Access Compliance Report

Public Rights-of-Way

Intersection ID: 24017	Main Street: DORNIER_CT	Cross Street: SILVER_DART_PL	Location: NE
ADA ID: CE52498B0326	Ramp Type: Directional1	Initial Pass/Fail: Fail	Overall Compliance: No
		Severity Score: 12.5

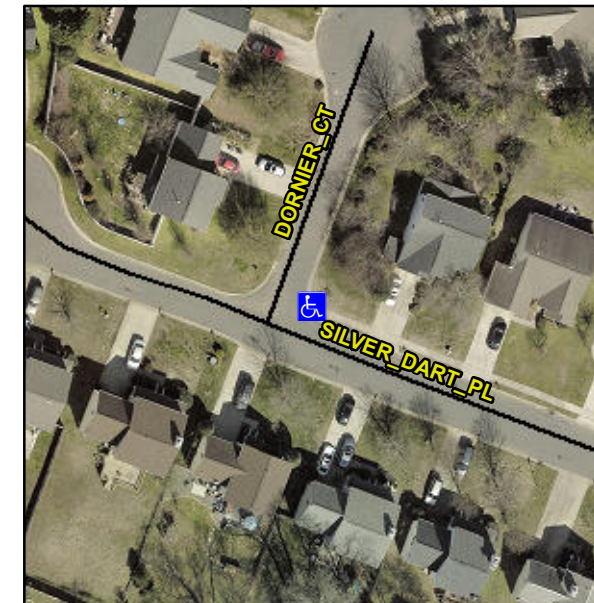
R304.5.3

Compliance	Description	Data	Compliance	Description	Data
N/A	Ramp Length (in)	35.5	N/A	Grade Break?	N/A
Yes	Ramp Width (in)	49.0	N/A	Grade Break Slope (%)	0.0
Yes	Ramp Slope (%)	2.0	N/A	Grade Break XSlope (%)	0.0
No	Ramp XSlope (%)	5.9			
N/A	Flare Type LT	N/A	N/A	Flare Type RT	N/A
N/A	Flare Slope LT (%)	N/A	N/A	Flare Slope RT (%)	0.0
N/A	Flare Traversable LT?	N/A	N/A	Flare Traversable RT?	N/A
N/A	Landing Length (in)	0.0	N/A	DWS Provided?	N/A
N/A	Landing Width (in)	0.0	N/A	DWS Contrast?	N/A
N/A	Landing Slope (%)	0.0	N/A	DWS Length (in)	N/A
N/A	Landing X Slope (%)	0.0	N/A	DWS Full Width?	N/A
N/A	Landing Curb? (Y/N)	N/A	N/A	DWS Offset LT (in)	N/A
N/A	Shared Landing?	N/A	N/A	DWS Offset RT (in)	N/A
N/A	Gutter Ponding?	0.0	N/A	Gutter Slope (%)	N/A
N/A	Gutter Lip Ht (in)	0.0	N/A	Gutter X Slope (%)	N/A
N/A	Painted X Walk1?	No		Road Slope (%)	3.3
	X Walk 1 Direction	To W		Road X Slope (%)	0.6
	X Walk 1 Width (in)	N/A		Clear Space?	N/A

Remove & Replace Entire Ramp.
